Amendments to the Drawings:

### REMARKS

*Fig. 1*  
PRIOR ART

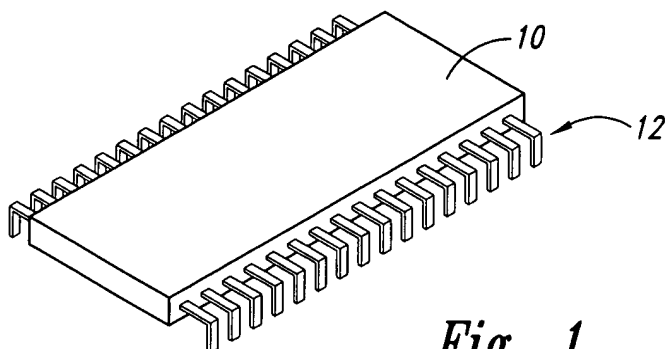
The attached sheets of drawings include changes to Figs. 1, 3A, and 3B. Figures 1, 3A, and 3B have been amended to state that they constitute prior art. Also enclosed are 5 replacement sheets for Figures 1-8.
